TITEL: Kontroll av bränsletankarnas urluftsningrör

GÄLLER: Modell R22 S/N 0002 tom 1451 se även under compliance i FAA AD 98-21-09

PRIORITY LETTER AIRWORTHINESS DIRECTIVE **Bilaga till LVD 2912**

98-21-09 ROBINSON HELICOPTER COMPANY: Docket No. 98-SW-45-AD.

FIGURE 2
AD 98-21-09

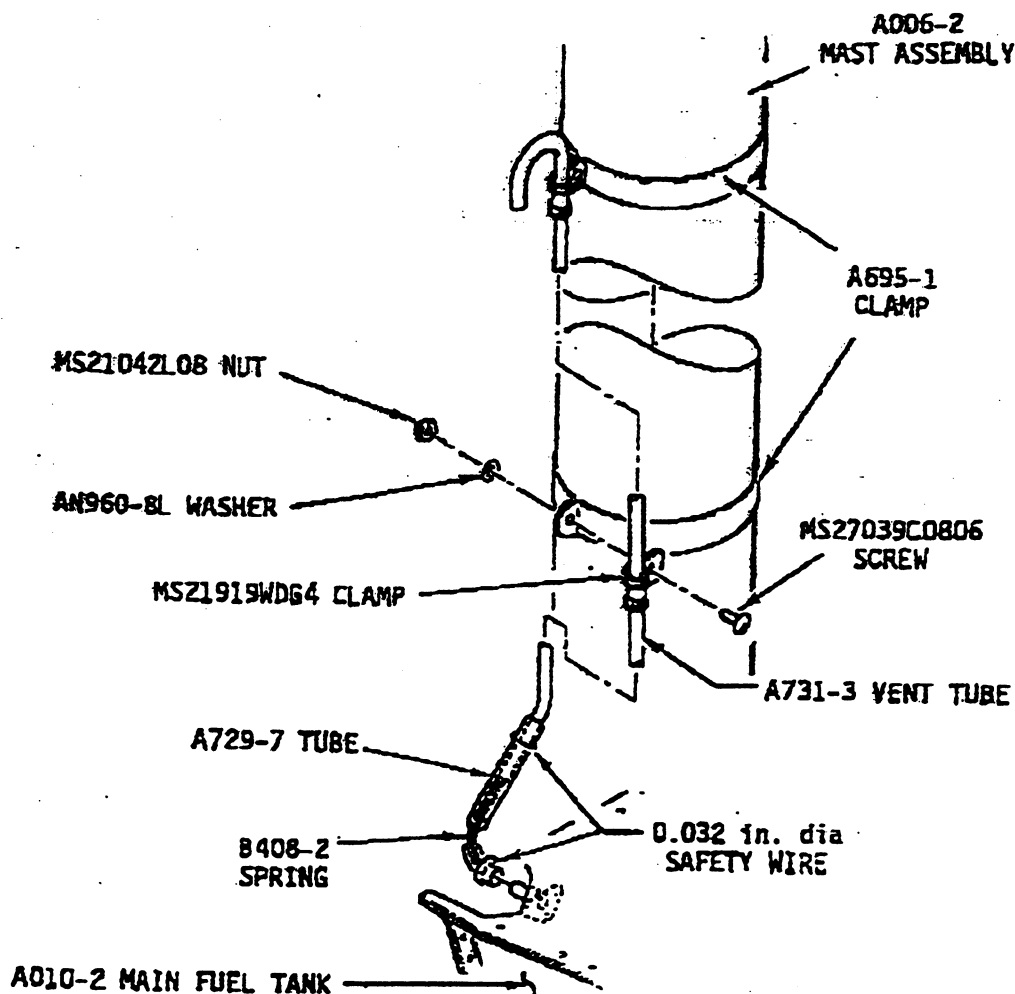
(2) For helicopters with an auxiliary fuel tank installed, remove the existing main fuel tank vent tube, P/N A731-1, and auxiliary fuel tank vent tube, P/N A731-2, and install airworthy vent tubes, P/N A731-3, with flexible tube, P/N A729-7, for main tank and flexible tube, P/N A729-17, for auxiliary tank using MS27039C0807 screw and AN960-8L washer (alternate P/N NAS1149FN816P) at lower clamp, P/N A695-1 (see Figure 2).

FIGURE 1
AD 98-21-09

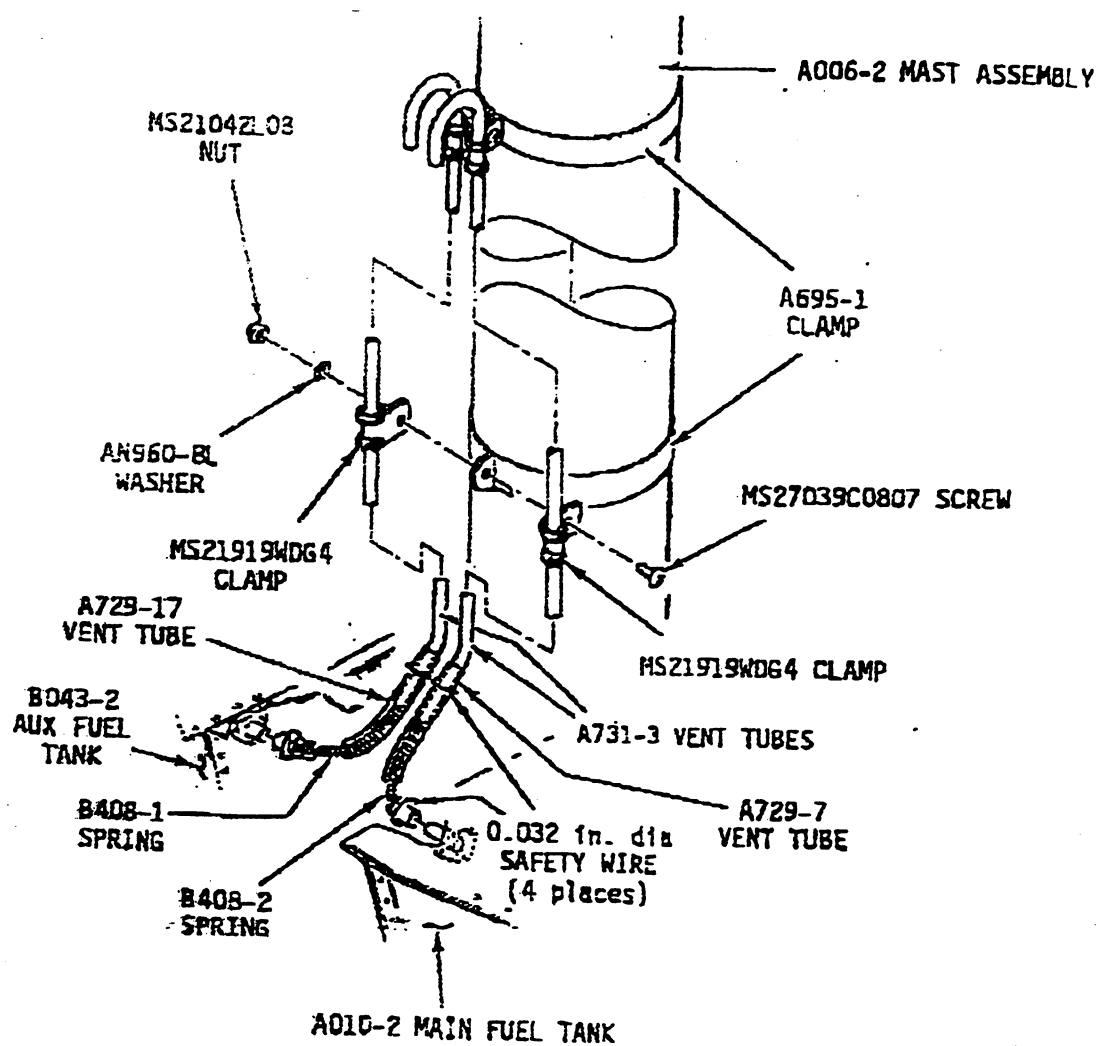
(1) For helicopters without an auxiliary fuel tank installed, remove the existing vent tube, P/N A731-1, and install an airworthy vent tube, P/N A731-3, with flexible tube, P/N A729-7, using a MS27039C0806 screw and AN960-8L washer (alternate P/N NAS1149FN816P) at the lower clamp, P/N A695-1 (see Figure 1).
